O P E N - F I L E R E P O R T 0 - 7 8 - 2

SUPPLEMENT TO THE FEBRUARY 11, 1974
PEBBLE SPRINGS REVIEW

Submitted to the Energy Facility
Siting Council on March 9, 1978
By Donald A. Hull, State Geologist

Fig. 2

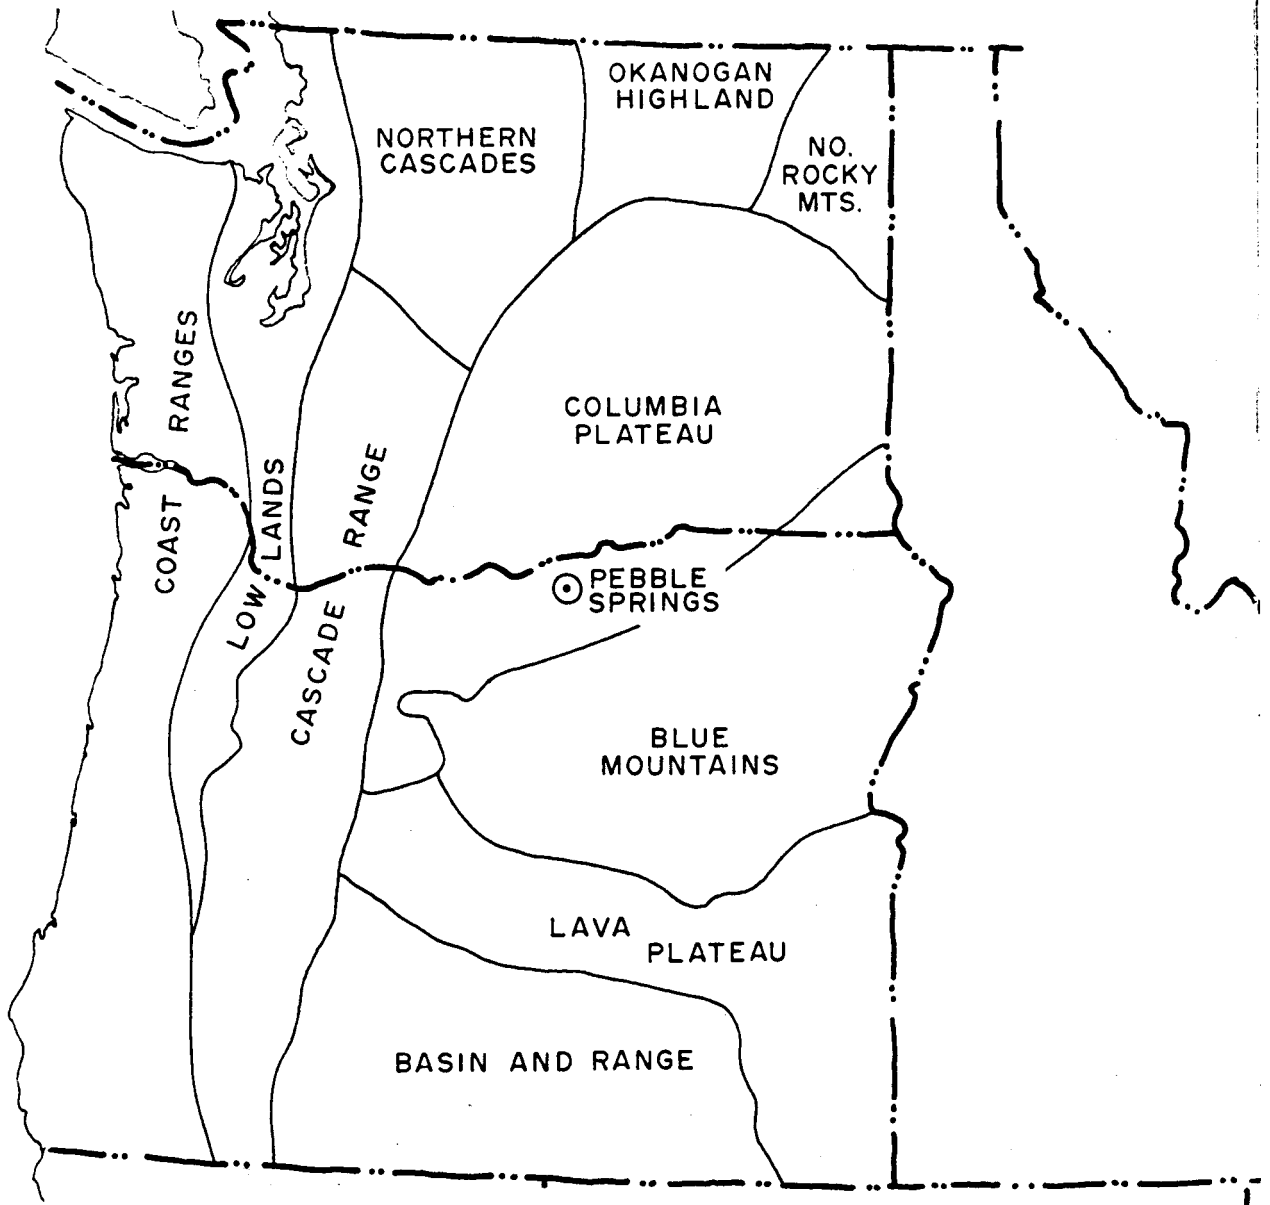
The Columbia Plateau was described as a separate distinct province from that of the Northern Cascades at the October, Portland meeting (see Figure 2). Therefore, since the 1872 earthquake has not been related to known surface faulting and the earthquake believed to have originated in the lower continental crust, we can assume that another such earthquake could occur on the margin of the Northern Cascade Province within 100 miles of Pebble Springs (see Figure 3).

Fig. 3

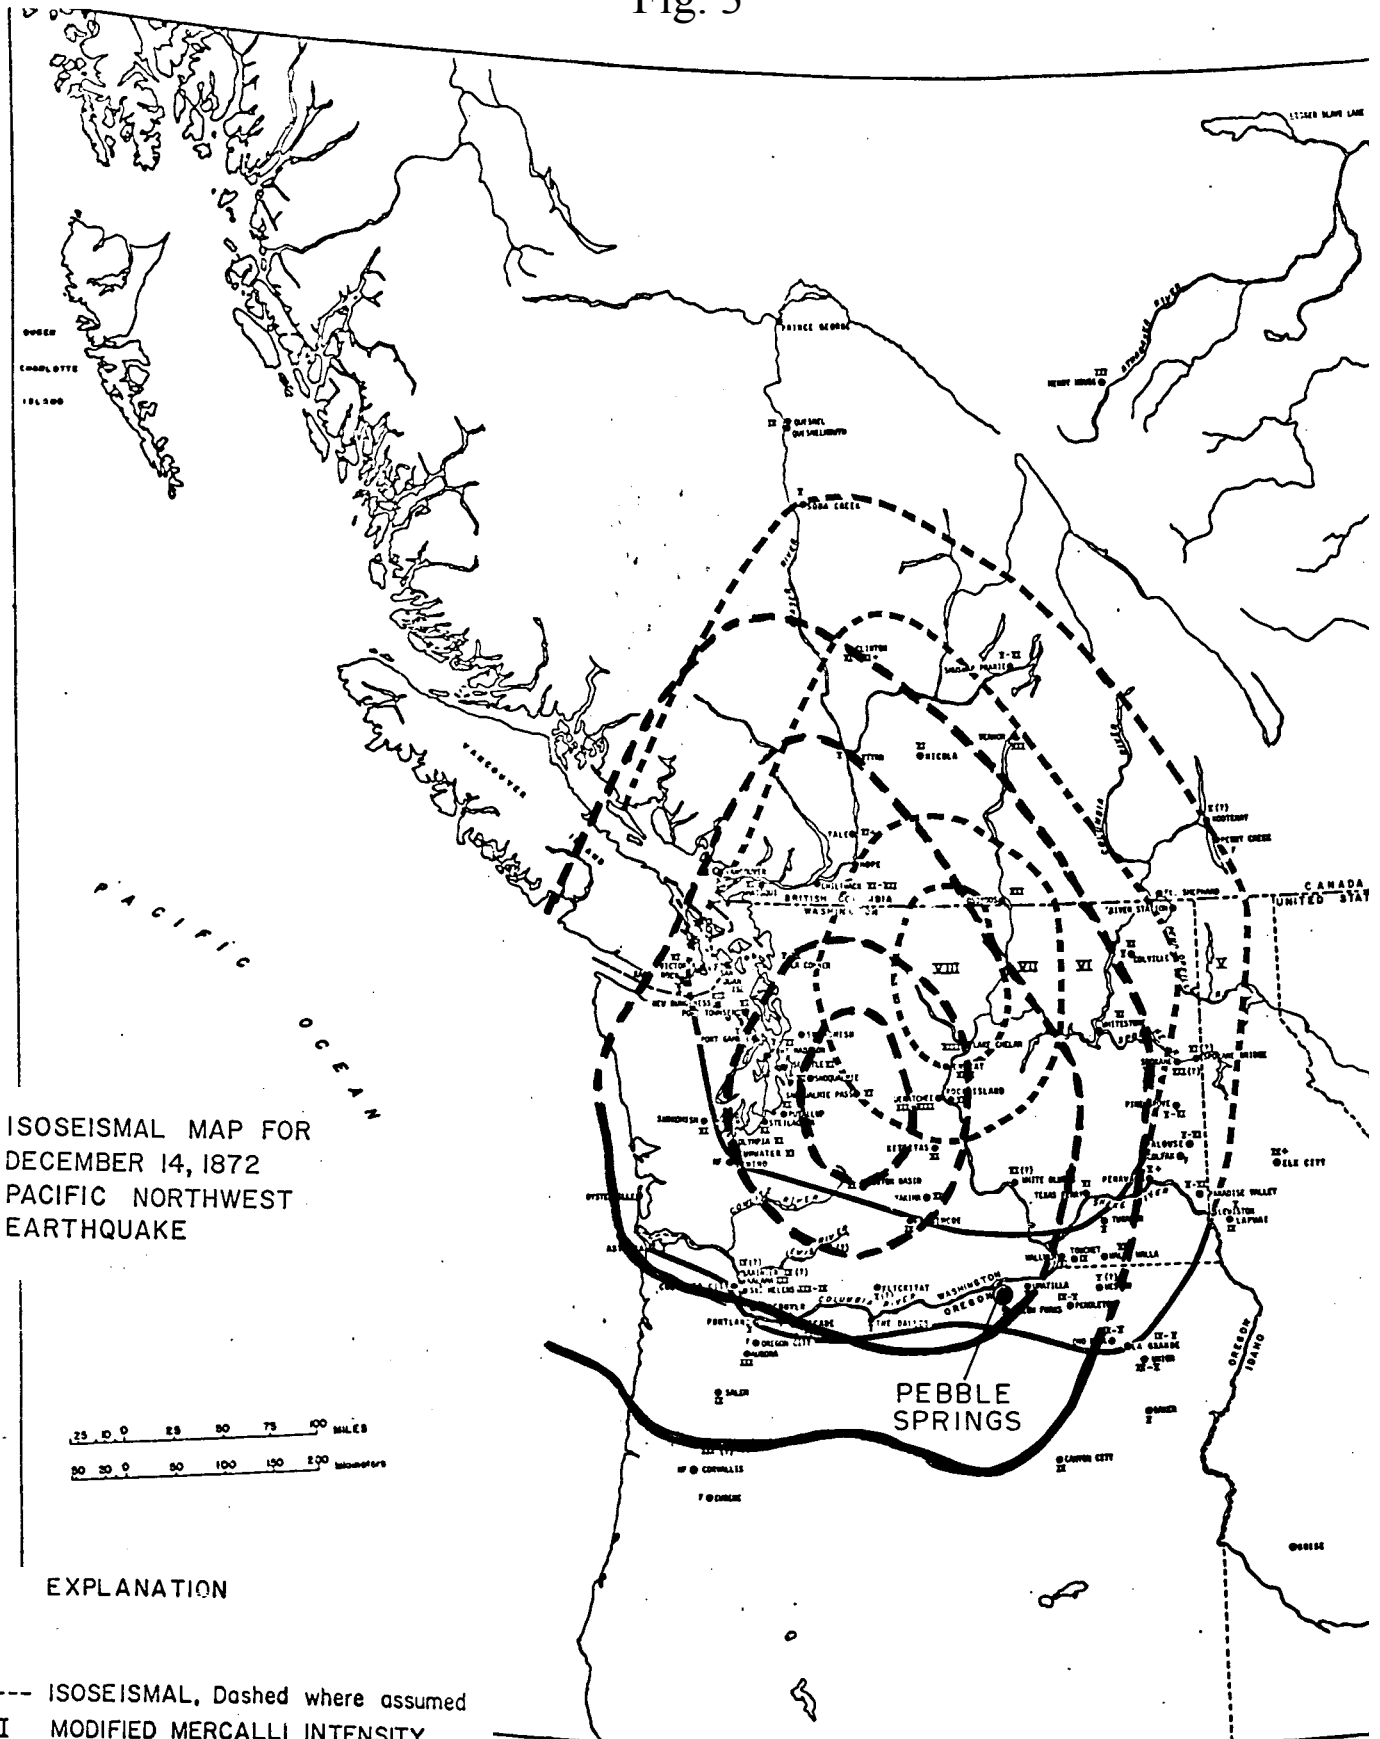
This relocation of the 1872 earthquake would place Pebble Springs within the VI isoseismal if the 1872 earthquake is rated Intensity VIII and within the VII isoseismal if the earthquake is rated Intensity IX. In either case the maximum seismic design for the Pebble Springs plant is adequate.

FIG. 5 POSTULATED "WORST CASE" ASH FALL - DISTANCE THICKNESS

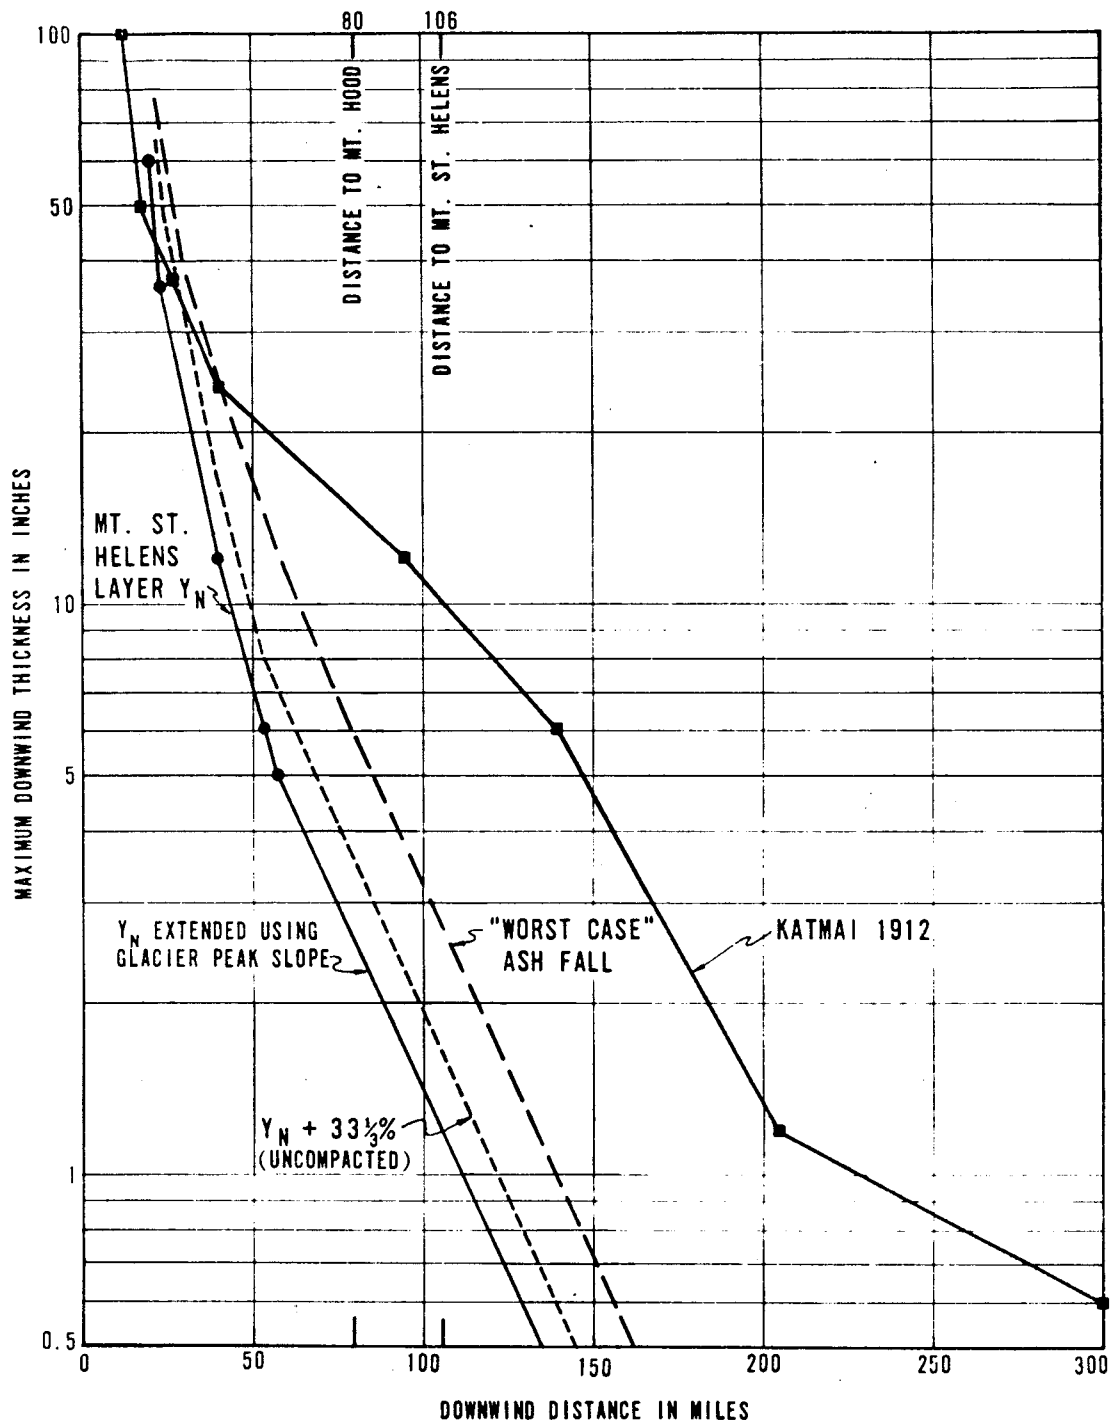
Shannon & Wilson conjectured that with all factors at "worst case" conditions, a total uncompacted ash fall at Pebble Springs could be 8.5 inches at a rate of 0.5 inches per hour for 9 hours (a compacted thickness of 5.5 inches). This was their recommended design basis for the Pebble Springs plant. Conversations between the authors and Donald Mullineaux, U. S. Geologic Survey in Denver, confirm that no new data has become available on volcanism in the Cascades to require changes in PGE's latest design assumptions.

We believe the conclusions reached by Shannon & Wilson, the U. S. Geological Survey and the National Regulatory Commission are well documented and reasonable. The design recommended using "worst case" conditions for a St. Helens type layer Y^N eruption cited by Shannon & Wilson are conservative in our opinion.
